REMARKS

Claims 1 - 9, 19 - 32, 38 and 45 - 46 remain active in this application. Claims 10 - 18, 33 - 37 and 39 - 44 have previously been canceled. Claims 1, 23, 31, 32 and 38 have been amended to improve form, clarity and accuracy in response to criticisms by the Examiner. Support for the amendments of the claims is found throughout the application, and in particular regard to claim 1, on page 21, lines 14 - 18. No new matter has been introduced into the application. The indication of allowability of the subject matter of claims 19 - 32 and 38 is noted with appreciation.

FIG. 14B

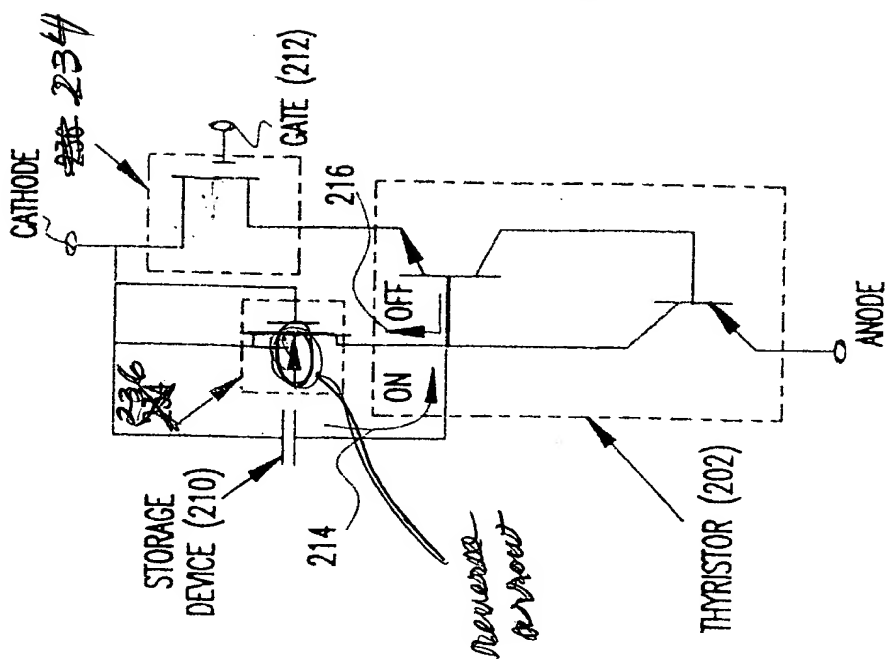
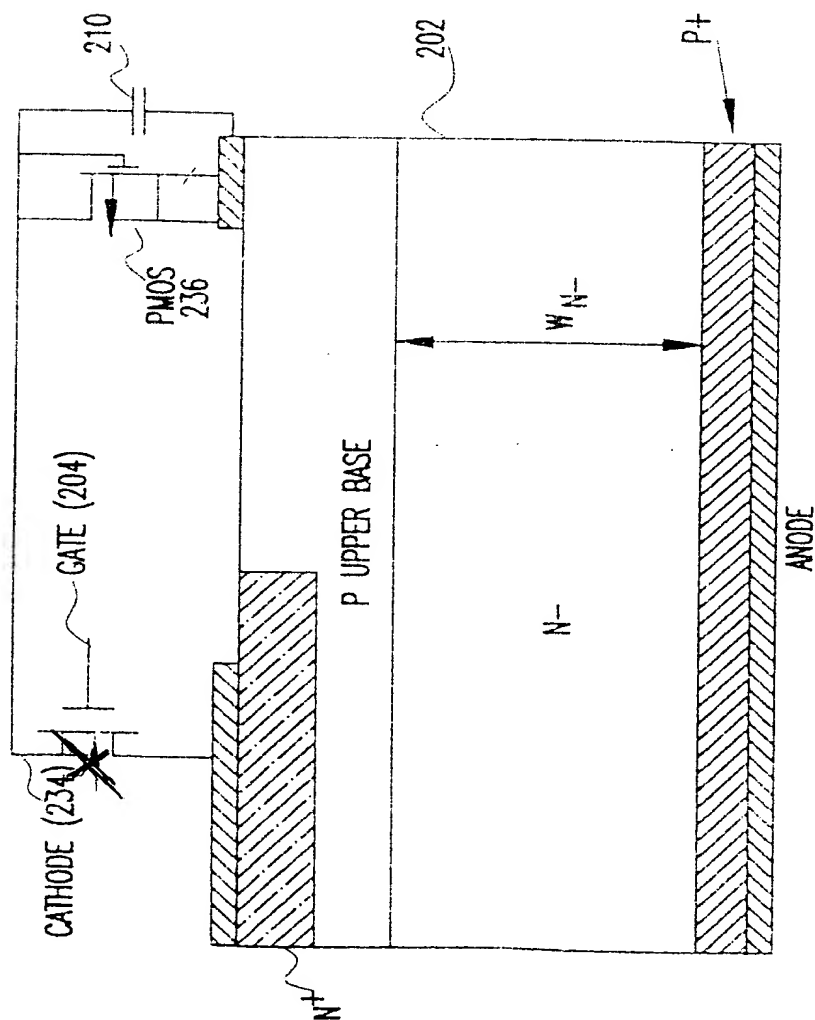
In regard to Figures 14A and 14B, upon review in light of the Examiner's criticisms, it was discovered that reference numerals 234 and 236 were reversed in Figure 14B as originally filed, as compared with Figure 14A. This revision can be verified by comparison to Figures 13A and 13B since Figures 14A and 14B are disclosed in the paragraph bridging pages 19 and 20 are similar to the circuit/device of Figures 13A and 13B but substituting PMOS transistors for NMOS transistors. Accordingly, approval has been requested, above, for an appropriate correction. The depiction of transistors

234 and 236 has been previously approved and such revisions have been made in regard to the depictions of the transistors as correctly identified and in a manner consistent between Figures 14A and 14B.
